TOWN OF HUDSON

PUBLIC MEETING TOWN OF HUDSON, NH FEBRUARY 28, 2018

75 Derry Street
McDonald's Restaurant Renovations
Site Plan Review
STAFF REPORT
February 28, 2018

Re: Town of Hudson Planning Board Review
McDonald's Site Development Plans, 73 Derry Road
Tax Map 165, Lot 155-1; Acct. #1350-907
CLD | Fuss & O'Neill Reference No. 03-0249.1670

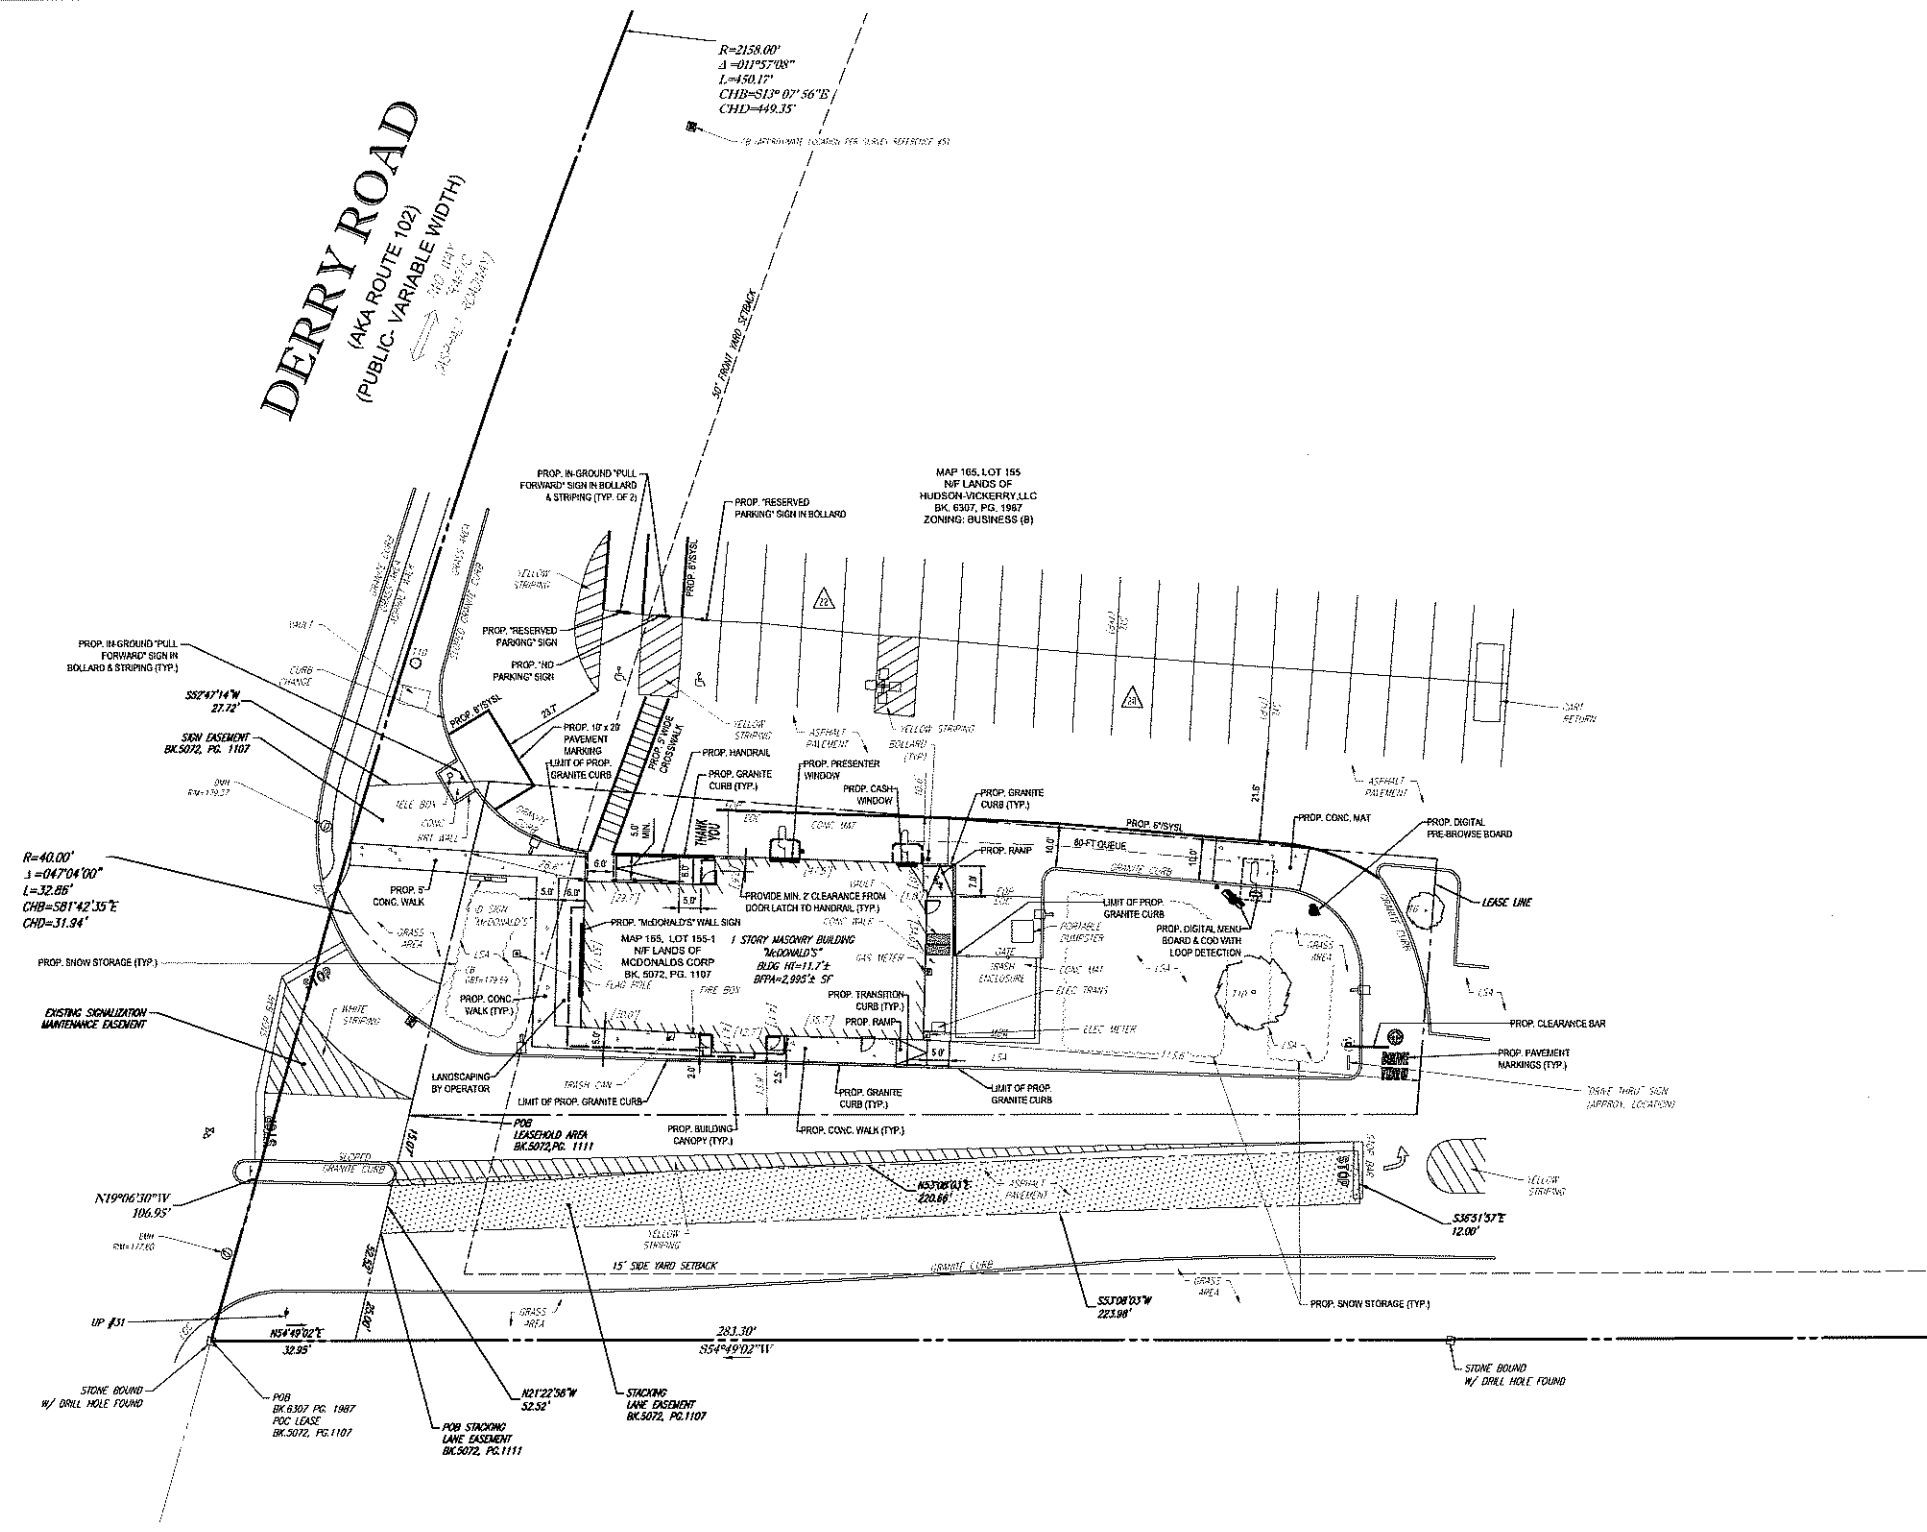
- 1) Provide within the sign summary table on Sheet C-4: a tabulation of existing and proposed quantities and area (sqft) of directional signs: "pull forward" and "enter" §334-68.
- 2) Provide within the sign summary table on Sheet C-4: a tabulation of existing and proposed quantities and area (sqft) of menu and pre-browse boards (signs).
- 3) Sheet C-4; Any signage proposed on the new canopy?
- 4) Sheet C-4; Notation in the sign summary tabulation indicates "existing" McDonalds sign to be removed and replaced with 34 sqft sign. Please indicate which compliance method is used: 20% of frontage or façade area, §334-63A.

An open space calculation has been added to Zoning Analysis Table on the Site Plan (sheet C-4).

An Open Space calculation has been added to the Zoning Analysis Table on the Site Plan (sheet C-4). Additional landscape plantings have been identified within the landscape schedule on Sheet C-6.

DIGITAL MENU BOARD DETAIL

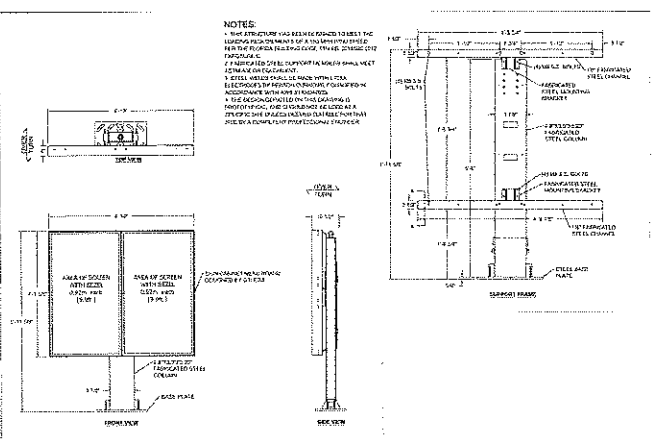
- a. The applicant didn't include a detail for the proposed concrete mat at the digital menu board.

DATE: DECEMBER 21, 2017 SCALE: AS SHOWN
PROJECT NO: 17-0503-2 SHEET 6 OF 6

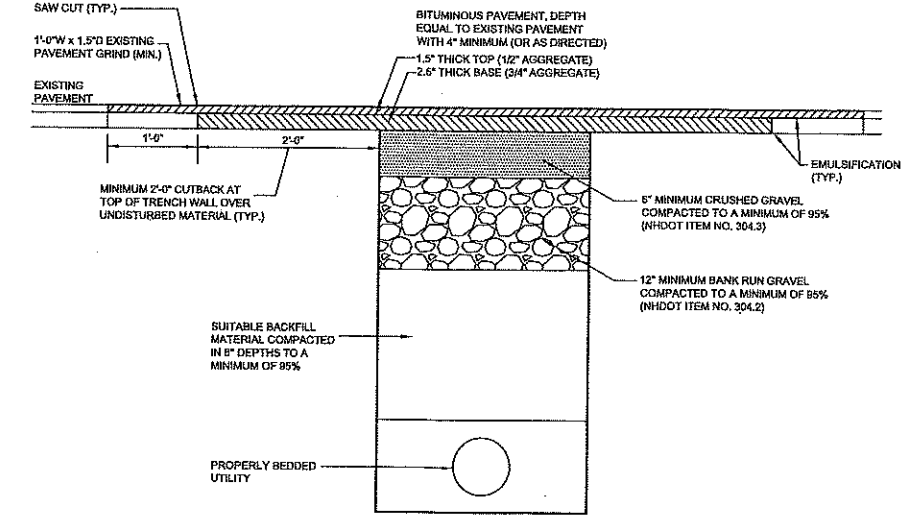
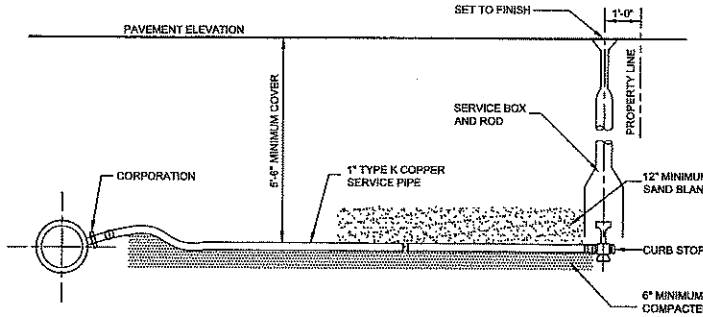
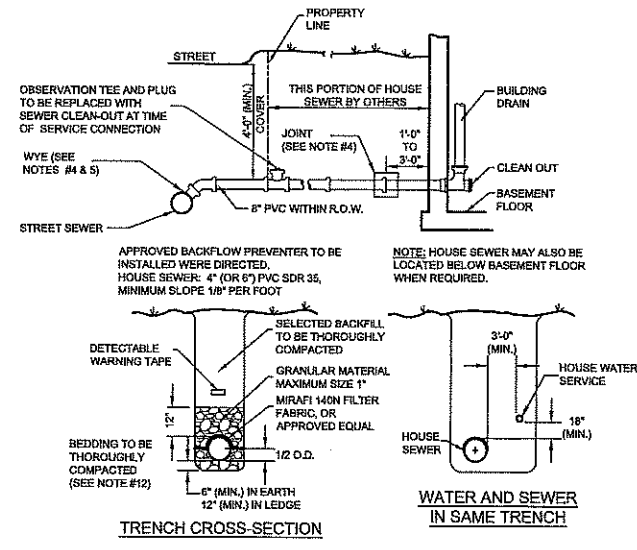
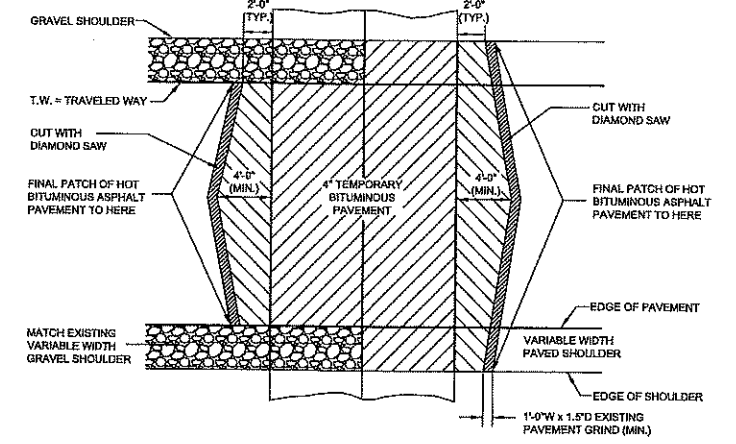
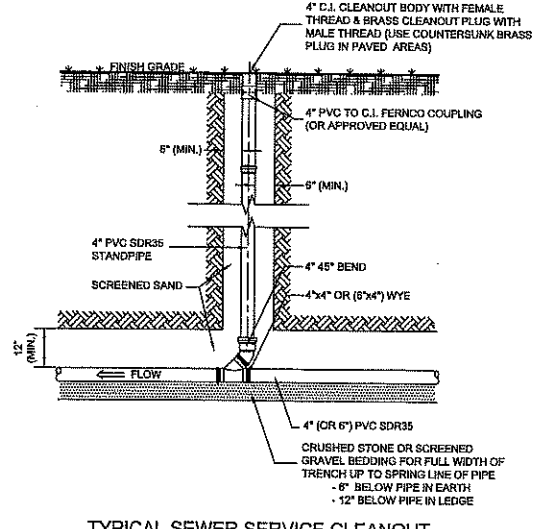
A Water Pipe/Sewer Pipe Separation detail was added to Sheet 6.

Water and Sewer Service Connection details have been added to Sheet 6.

A Permanent Pavement Patch detail was added to sheet 6.

The sizes and types are unknown since no development is proposed. Provided on sheet 6 are the typical details for the Town of Hudson. In order to connect to the Town's services, applications will be filed with the Town Engineer at the time of construction and compliance to the standard will be required.
